**REQUEST**

Current Zoning: O-3 (office)  
Proposed Zoning: MUDD-O (mixed used development, optional)

Approximately 9.94 acres bound by the south side of Fairview Road, east side of Piedmont Row Drive South, and the north and west side of Barclay Downs Drive.

SouthPark Towers PropCo, LLC

### • Proposed Request Details

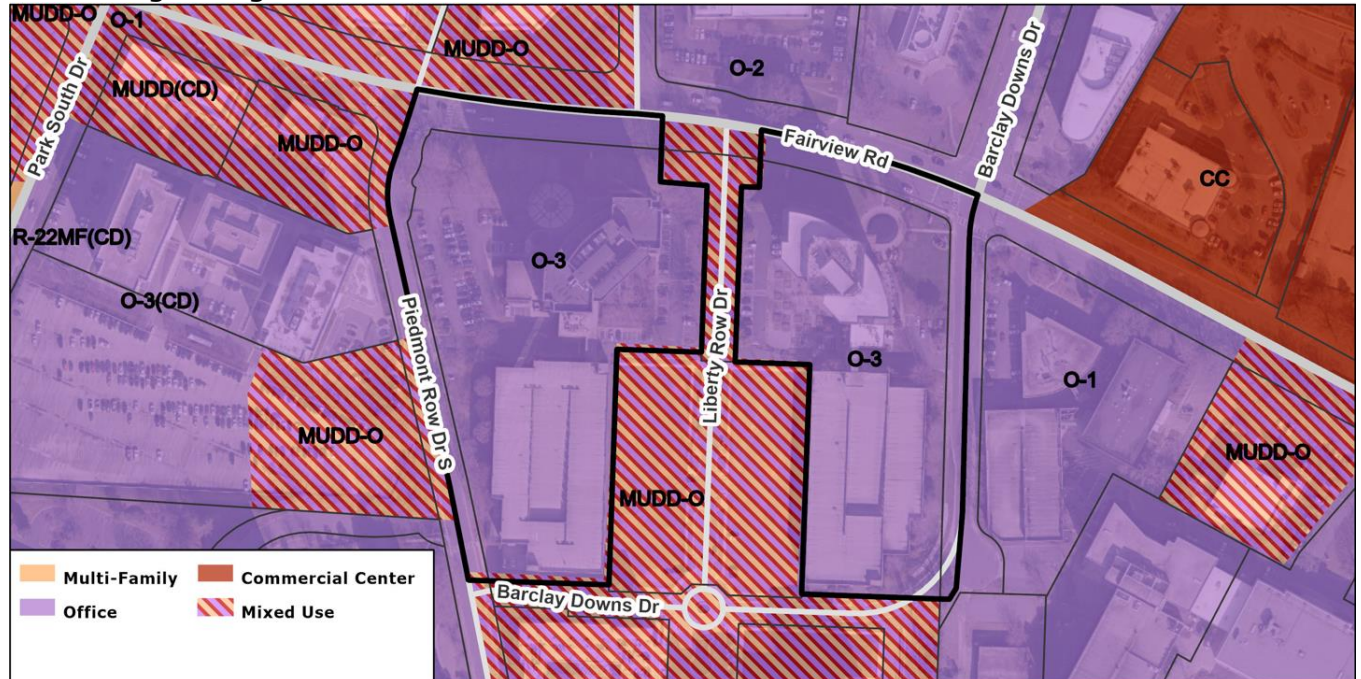
1. Revise site plan and conditional note(s) to commit to dedicate 63 feet of right-of-way from the Fairview Road centerline. The site plan shall label and dimension the right-of-way from the road centerline.
2. Update conditional note V.d.ii.iii. to change "WB" to "EB" as the southern crosswalk is along the eastbound direction on Fairview Road.

3. Design standards are inadequate. If the petitioner does not want to incorporate new UDO standards, reference and incorporate standards from RZP 2020-059 as a baseline.

4. Amend the optional provision #2 related to existing parking to include Area B as there is existing parking between the building and Barclay Downs Dr.
5. Include note that any changes to the existing buildings will not increase their degree of nonconformity.
